Urgent Field Safety Notice

Subject: Software updates for Cardiac Resynchronization Therapy Defibrillators (CRT-Ds) and Pacemakers (CRT-Ps) address the December 2017 Positive Left Ventricular (LV) Offset Interaction.

Summary Field Safety Notice (FSN)

Appendix A – Identification of Programmer Software

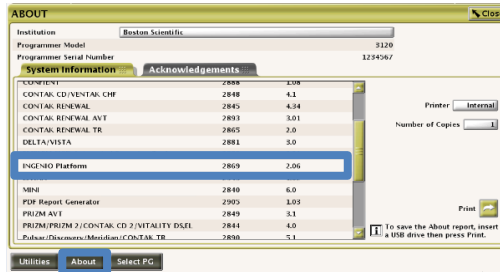
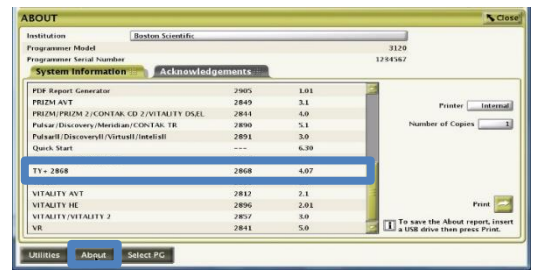
Confirm your
Programmings
have software
upgrades

Select About
button and
Confirm
Software
Model and
Version

Model 2869 v2.06
Supports CRT-Ps in Table 2

Model 2868 v4.07
Supports CRT-Ds in Table 1

Supported devices interrogated with this software are no longer at risk of permanent Safety Mode status due to a parameter interaction between positive LV Offset, A-Blank after V-Pace values, and Tracking Preference.
